ADDENDUM | No. 1

PROJECT	Westside Sanitary Sewer Extension – Phase 1
BID DATE	2:00 PM Central Time Zone 10/19/2022
BID LOCATION	Harrisburg City Hall 301 E. Willow Street, Harrisburg, SD 57032
ISSUE DATE	10/12/2022
NOTICE	Failure to acknowledge all addenda in the BID may cause rejection of the BID. See Instructions to Bidders.

SHEET No. : **I-27R**

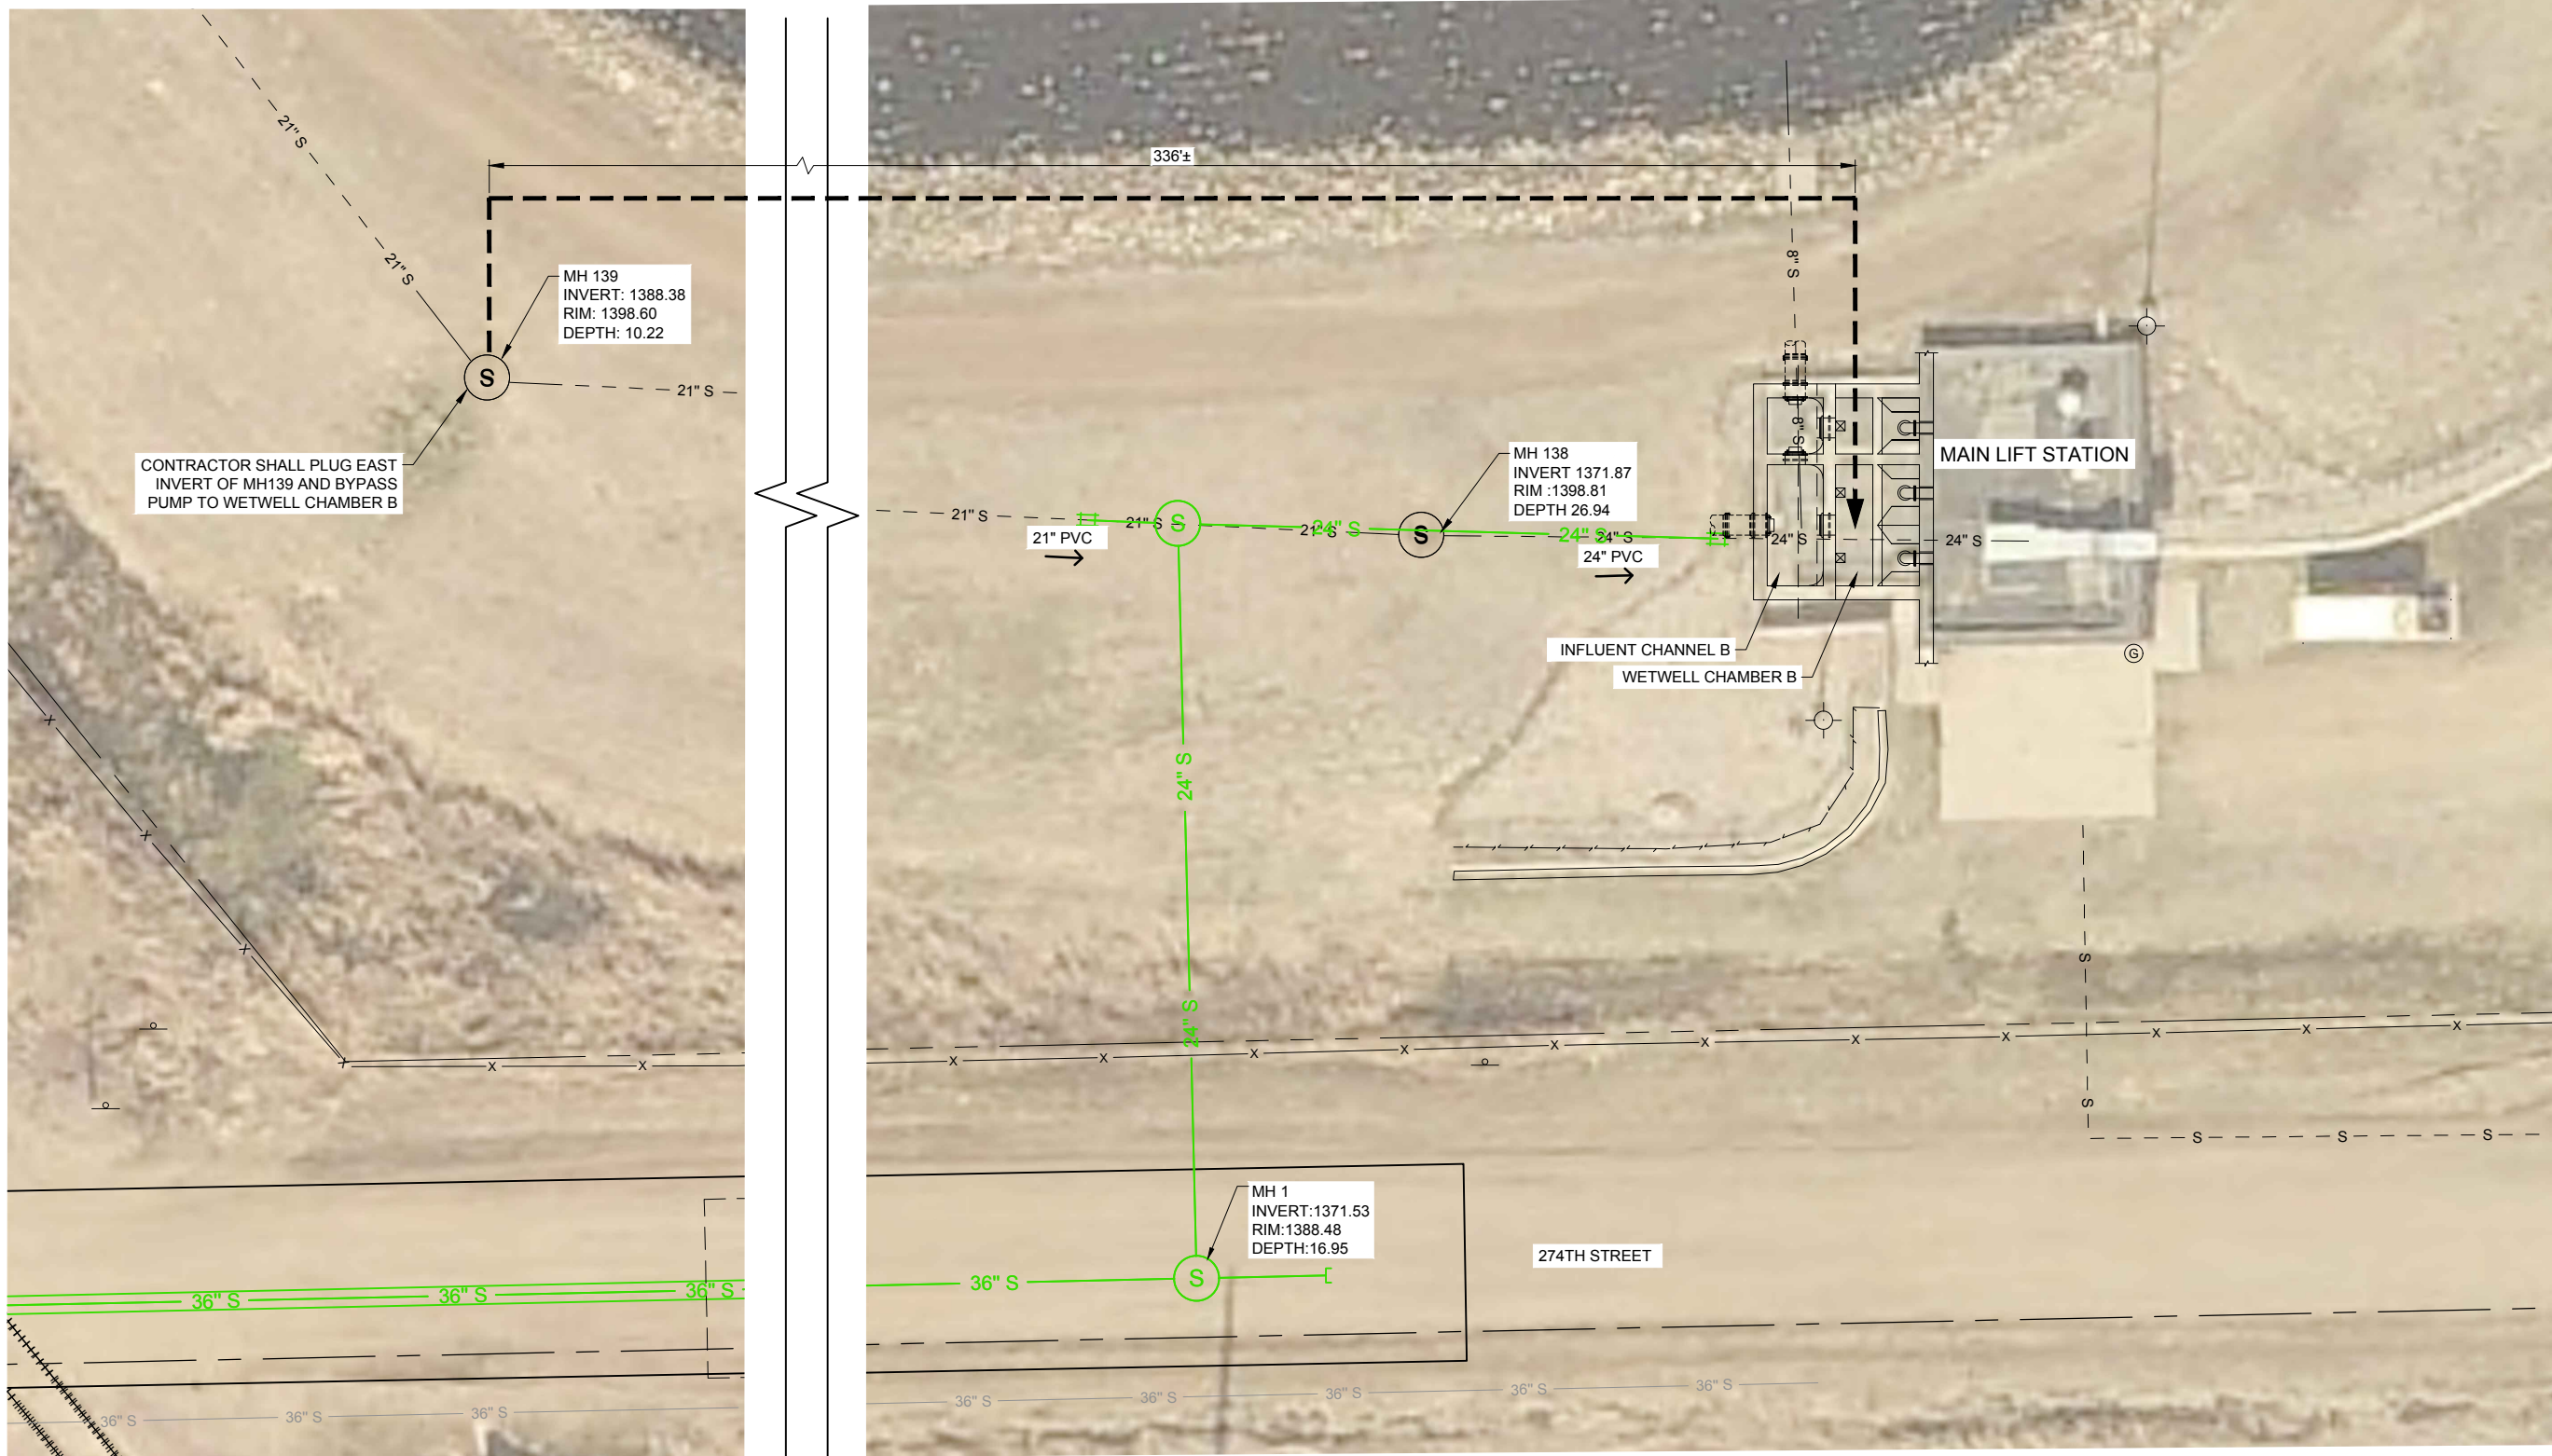
Replace existing Sheet I-27 with attached Sheet I-27R. Bypass pumping is being relocated to an upstream manhole.

1. SANITARY SEWER BYPASS REQUIRED FOR TIE-IN UPSTREAM OF MAIN LIFT STATION. CONTRACTOR SHALL USE UPSTREAM MANHOLE ON SEWER PIPING BEING BYPASSED. CONTRACTOR TO DIRECT BYPASS TO WETWELL CHAMBER B AND PROVIDE TEMPORARY GRATING TO PREVENT FALL HAZARDS AROUND BYPASS PIPE. CONTRACTOR TO DEVELOP AND SUBMIT BYPASS PUMPING PLAN PER GENERAL NOTES.

REV.	DATE	DESCRIPTION
1	10/5/22	BYPASS ROUTE REVISED TO MH 139

SANITARY SEWER CONCRETE THRUST BLOCK FOR CAP

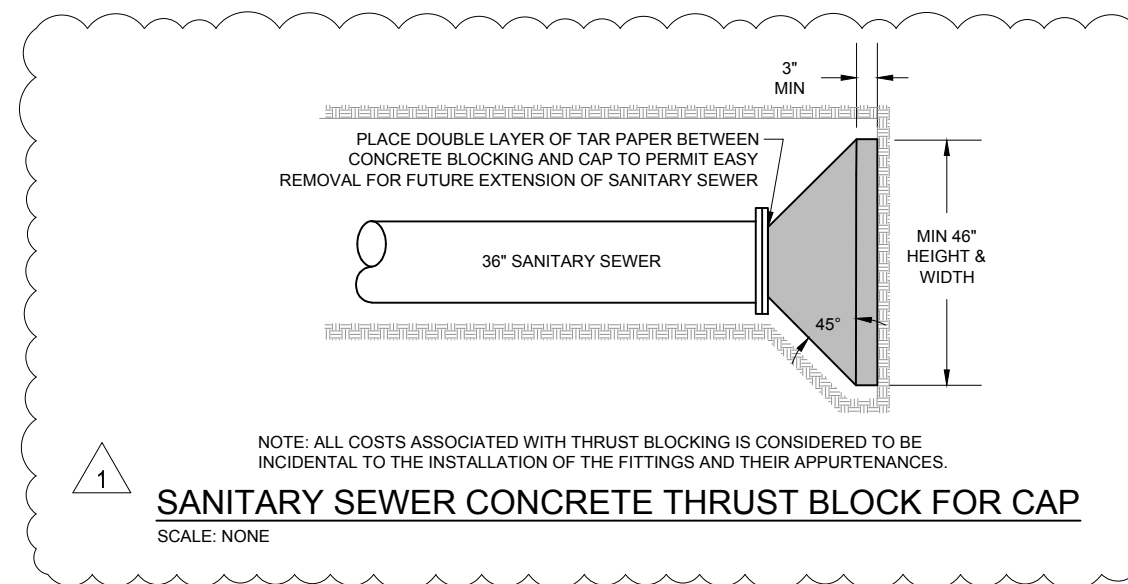
1 EA – SEWER CAP WITH CONCRETE THRUST BLOCK FOR CAP (SEE DETAIL) per the "SANITARY SEWER CONCRETE THRUST BLOCK FOR CAP" detail provided with this addendum.

Replace existing Sheet N-18 with attached Sheet N-18R. Sanitary Sewer Concrete Thrust Block for Cap detail has been added to sheet.

REV.	DATE	DESCRIPTION
1	10/5/22	ADDED DETAIL

SHEET No.: N-20R

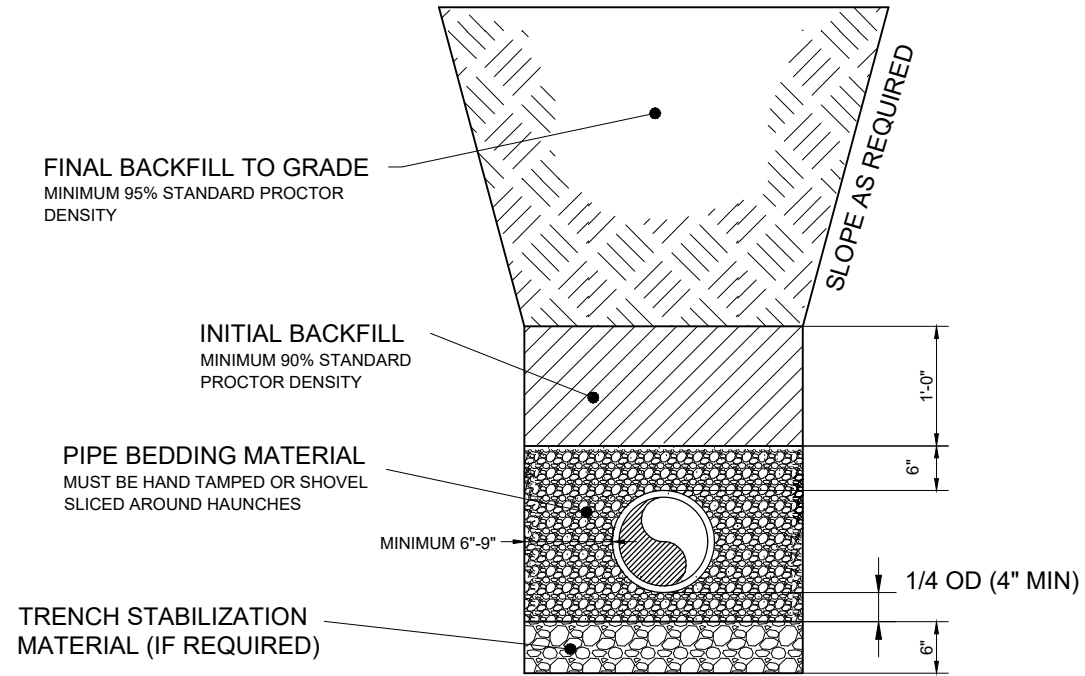
Add Sheet N-20R to include a bedding detail for HOBAS pipe.

1. BEDDING MATERIAL SHALL BE CLEAN ANGULAR, WELL-GRADED, CRUSHED ROCK.
95% PASSING 3/4" SIEVE
95% RETAINED #4 SIEVE
2. THE REQUIRED BEDDING MATERIAL UNDER THE BOTTOM OF THE PIPE SHALL BE INSTALLED PRIOR TO PIPE INSTALLATION
3. TRENCH STABILIZATION MATERIAL WILL BE REQUIRED IF SOFT, SPONGY, UNSTABLE OR OTHER SIMILAR MATERIAL IS ENCOUNTERED WHERE THE PIPE IS TO BE PLACED. SPECIFICATIONS AS PER MANUFACTURER'S RECOMMENDATIONS AND A.S.T.M. C12. ENGINEER SHALL DETERMINE IN THE FIELD IF NECESSARY.
